PATENT

Amendments to the Drawings:

Appl. No. 10/773,800 Response to Office Action Mailed June 3, 2005

FIG. 1 (Prior Art)

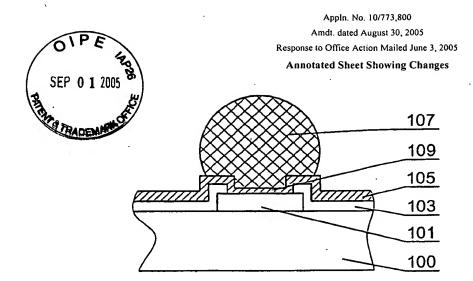
The attached sheet of drawings includes changes to Fig. 1 This sheet, which includes Fig. 1 replaces the original sheet including Fig. 1.

In the latest Office Action, the Examiner objected to Figure 1 and indicated that this figure should be designated by a legend such as "Prior Art". Applicant has now amended Figure 1 to include the legend, and it is respectfully asserted that the objection to Figure 1 has been overcome.
